<b>FEI - CPCN FOR THE TILBURY LNG STORAGE EXPANSION PROJECT      EXHIBIT A-44</b>
---

**Re: FortisBC Energy Inc. – Application for a Certificate of Public Convenience and Necessity for the Tilbury Liquefied Natural Gas Storage Expansion Project – Project No. 1599170 – Adjournment**

## Application for a Certificate of Public Convenience and Necessity for the Tilbury Liquefied Natural Gas Storage Expansion Project

### Decision and Order G-62-23

**Figure 1: Tilbury Regasification Capacity Relative to Lower Mainland Load**

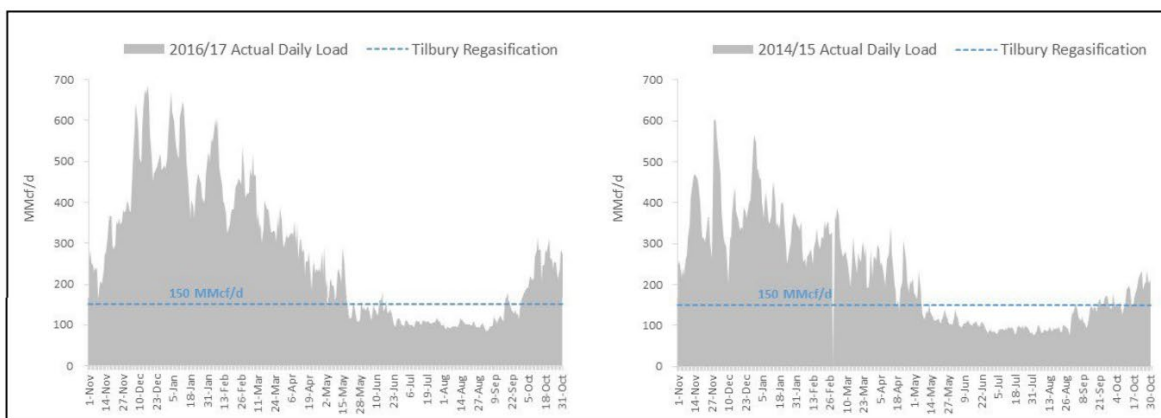
FEI also states that<sup>44</sup>

For approximately 200 days of the year, FEI would not be able to supply the single-day load requirements of the Lower Mainland. Large portions of the Lower Mainland system, equivalent to entire municipalities, would have to be shut down within hours of a no-flow event on the T-South system occurring in a normal winter. This is due to the fact that, no matter how much storage is assumed to be available at Tilbury (including the Tilbury T1A tank), the limited regasification capacity at Tilbury (150 MMcf/day) constrains FEI’s ability to regasify and send-out stored volumes of LNG at Tilbury into FEI’s Lower Mainland system.

**Figure 2: Lower Mainland Load Duration Curves**

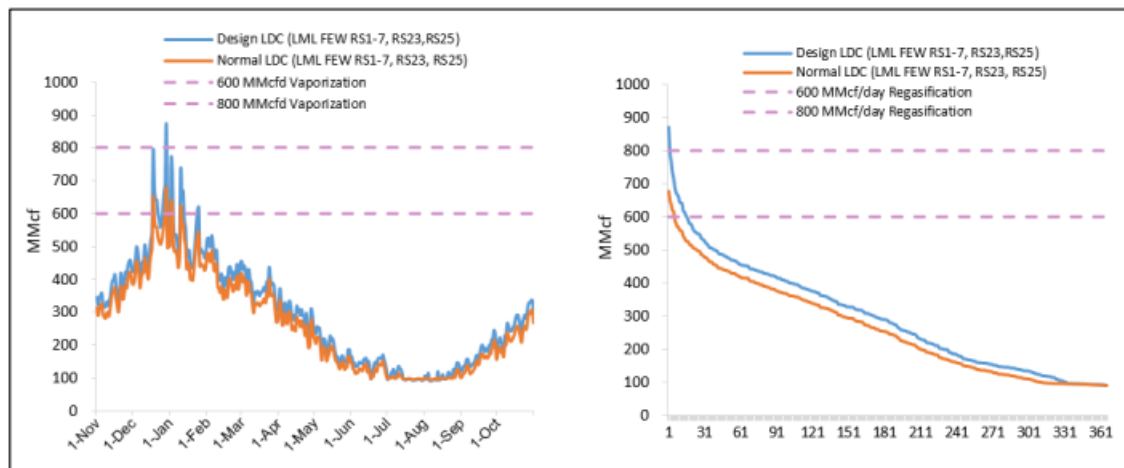
Based on the load duration curve below, the design peak demand for the Lower Mainland is 871MMcf/day for 2019/20.

FEI notes that the load duration curve declines steeply, such that the second coldest day on the design load duration curve (blue) is 793 MMcf/day. FEI submits that the figures above demonstrate that the proposed regasification capacity of 800 MMcf/day is adequate to cover Lower Mainland

**Figure 3: Tilbury Base Plant and Tilbury 1A Facilities – Current Configuration (2020)** <sup>97</sup>

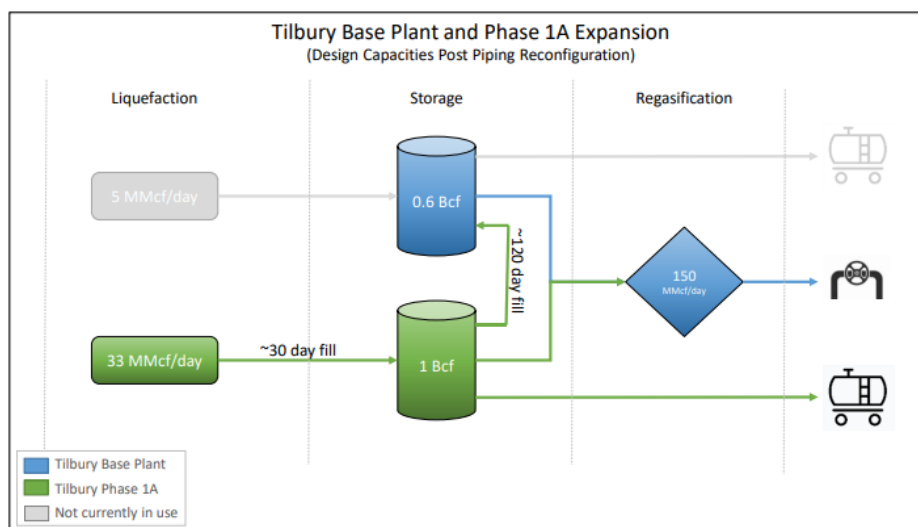
Although the design capacity of the Base Plant tank is 0.6 Bcf as shown in Figure 3-13 above, FEI is currently operating the tank at a reduced capacity while it assesses the future operability of the tank. In the interim, FEI will temporarily utilize a portion of the capacity of the Tilbury 1A tank to replace the reduction in the Base Plant tank storage. FEI's interim operating strategy, relying in part on the Tilbury 1A facilities, has several advantages, including increased equipment reliability, decreased time to replenish LNG inventory, and improved environmental performance. The following table summarizes the design capability of the Tilbury LNG facility today:<sup>98</sup>

**Figure 4: Tilbury 1A Storage Tank Level**

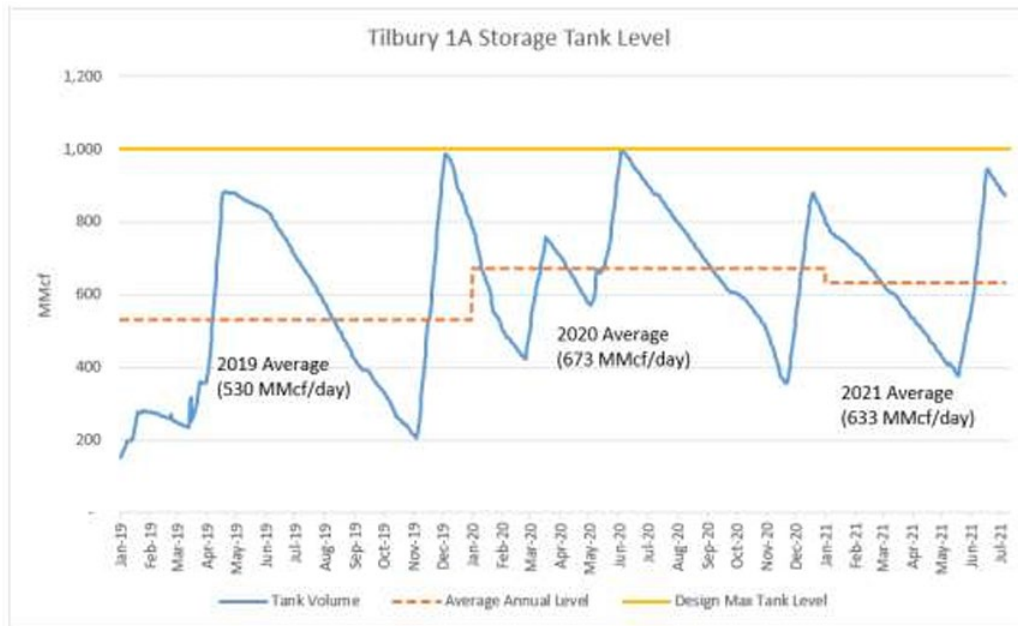
In the proceeding, the potential to use Tank 1A was explored. The figure below shows the historical storage tank level from January 2019 to July 2021.<sup>99</sup>

When asked why FEI does not seek to maximize storage volumes, it responded:<sup>100</sup>

When considering the optimum storage levels for the Tilbury T1A tank, FEI must consider the cost of LNG production. The Tilbury T1A liquefaction facility produces up to 1500 cubic metres of LNG per day, which would fill the T1A storage tank from empty in approximately 30 days. The draw-down of LNG from the tank depends on the volume of LNG sales. From 2019 to present, LNG sales have not been equal to the LNG production capacity. As a result, the liquefaction plant must shut down to allow the LNG storage levels in the tank to drop sufficiently to restart liquefaction.

Each startup of the liquefaction facility requires additional effort, including pre-start checks and activities, and there is increased stress on rotating equipment during starts and shutdowns. For these reasons it is desirable to minimize the number of startups throughout the year. While FEI could run the plant at lower rates to fill the tank more slowly, the energy efficiency of the plant is impacted at lower production rates, meaning there would be a higher cost to produce LNG. Based on the above considerations, FEI balances the overall cost and equipment impacts by optimizing production runs to reduce operator effort during startups, preserve energy efficiency (i.e., run at design rates), and minimize the number of stops and starts during the year. Tilbury T1A has only been in operation for two years (including operating through the COVID-19 pandemic, which has impacted LNG sales). As a result, the storage levels reported in the above graph may not be indicative of future storage levels.
